## **PARKERS COMMON SUBDIVISION**

Engineering Comments: FINAL PLAT COMMENTS (should be addressed prior to submitting the FINAL PLAT for review and/or signature by the City Engineer):

APPLICATION NUMBER 5 DATE December 6, 2018

# DETAIL SITE PLAN

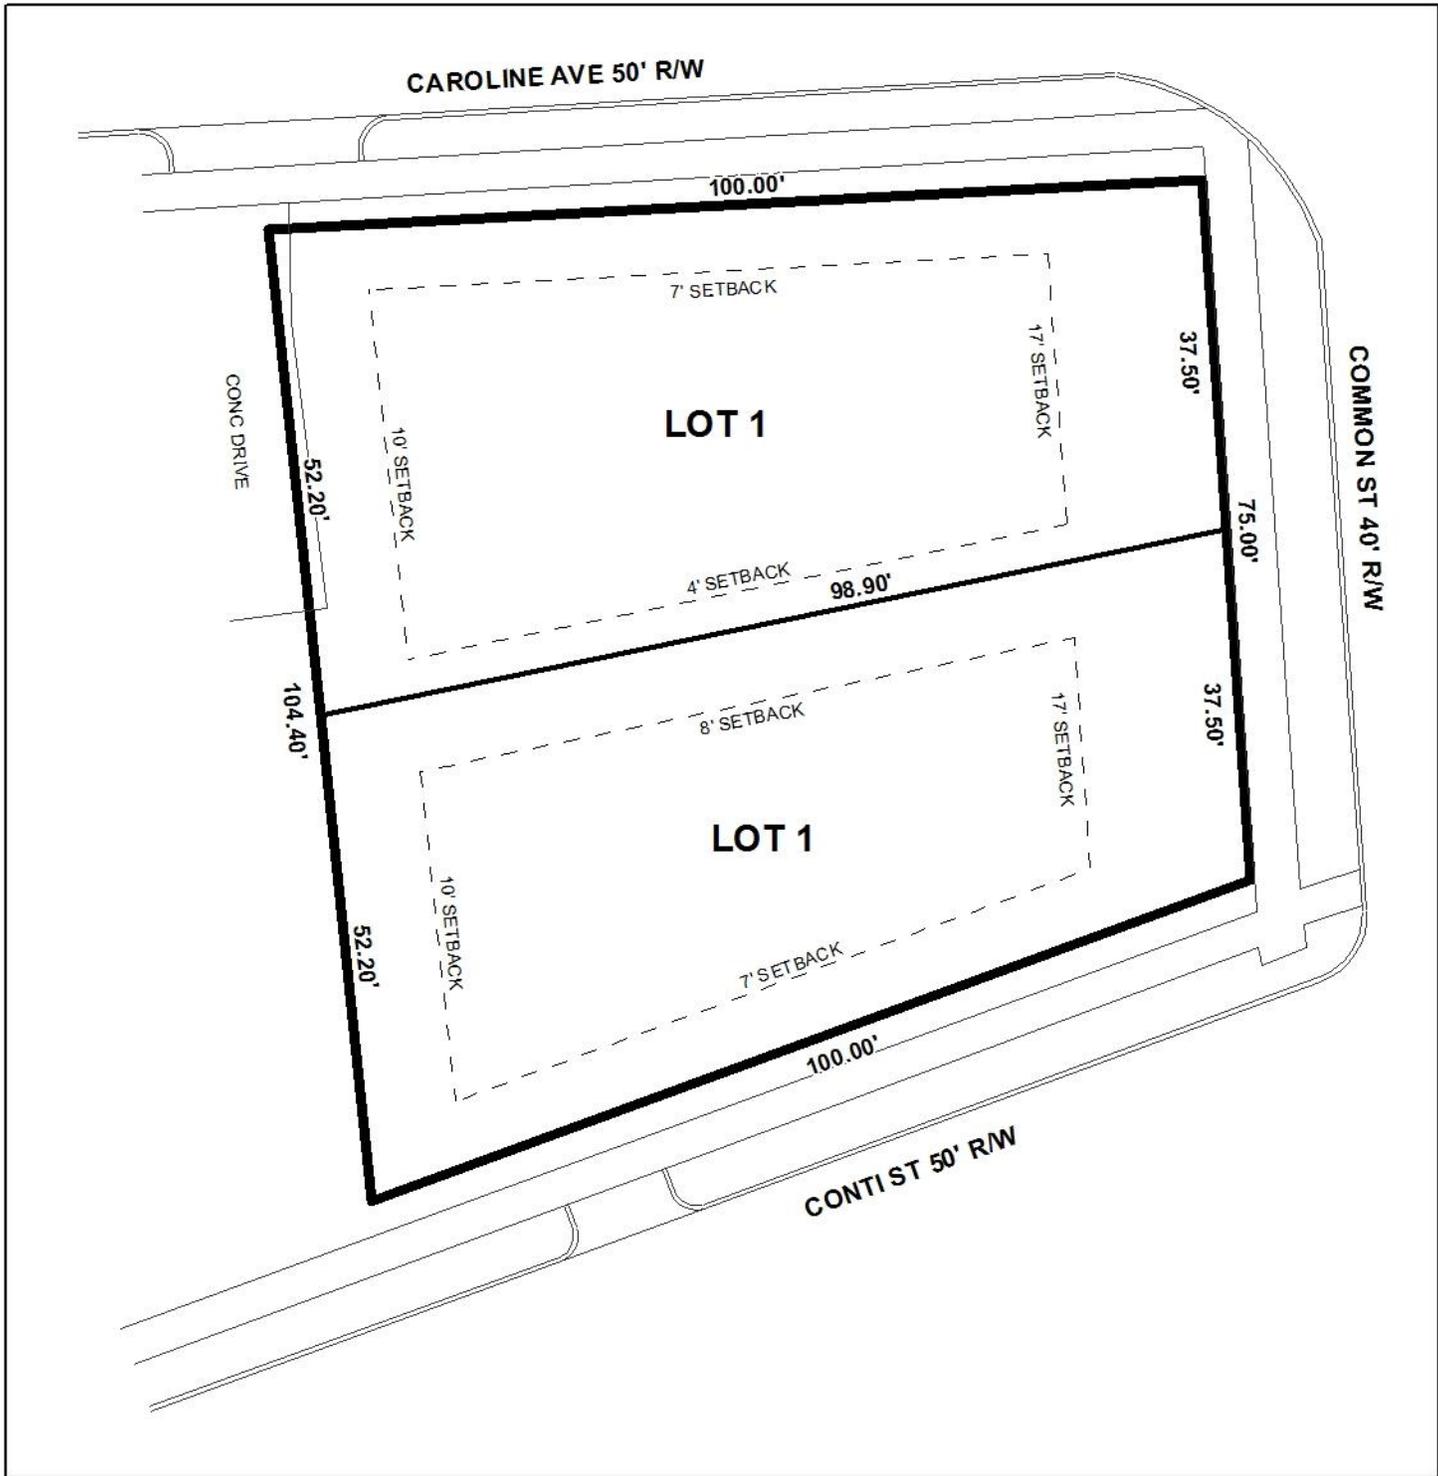
Proposed Lot 1 has frontages along Common Street and Caroline Avenue. Proposed Lot 2 also has frontage along Common Street, as well as along Conti Street. Each of these streets is a minor street with curb and gutter, thus requiring 50' right-of-way widths. Adequate rights-of-way are illustrated along Caroline Avenue and Conti Street, but not along Common Street. As such, if approved, dedication should be made to provide 25' from the centerline of Common Street.

Dedication of 25' corner radii at the intersections of Common Street and Caroline Avenue, as well as at Common Street and Conti Street, should be required, if approved, in compliance with Section V.D.6 of the Subdivision Regulations.

Neither lot, as proposed, meets the minimum size requirements of Section V.D.2. of the Subdivision Regulations, with Lot 1 comprised of 4,444± square feet, and Lot 2 comprised of 4,370± square feet. Additionally, each lot is substandard in width, with both proposed lots having 37.5'± of frontage along Common Street. While such lot designs may be common within the vicinity of the subject site, most are not legal lots of record and do not, therefore, constitute a means by which precedence can facilitate approval of additional substandard lots. Furthermore, the proposed lots would subdivide a metes-and-bounds parcel that would otherwise meet the minimum size requirements of the Subdivision Regulations if it were recorded as a single legal lot. Nevertheless, the lots are labeled with their sizes in square-feet and acres, which should be retained on the Final Plat, if approved, adjusted for dedication; or, provision of a table on the Final Plat providing the same information may suffice.

A 17' minimum building setback line is illustrated along Common Street for both lots, which does not meet the 25' minimum building setback requirement of Section V.D.9. of the Subdivision Regulations. It should also be noted that a substandard side yard setback is illustrated along the interior lot line of proposed Lot 1, and substandard corner side yard setbacks are illustrated on both lots. Additionally, a 10' rear yard setback is illustrated on both lots.

If approved, the substandard width of the lots would permit at least a 7' corner yard setback, as well as increased side and rear yard setbacks, but not reduced front and side yard setbacks. The lots are within the Old Dauphin Way Historic District, as mentioned, and, if approved, would benefit from flexible development requirements via the Historic District Overlay, to include reduced setbacks. Evidence of Historic District Overlay compliance to justify recording such unconventional setbacks was provided by the applicant, to include the houses at 16 and 18 Common Street, which have reduced side and front yard setbacks; however, the sizes of the proposed lots still would not meet the minimum size requirements of the Subdivision Regulations, especially after dedication, which may not be justified by the Historic District Overlay.

Based on the preceding the plat is recommended for Denial due to the following:

- 1) the proposed lot sizes do not comply with Section V.D.2. of the Subdivision Regulations.
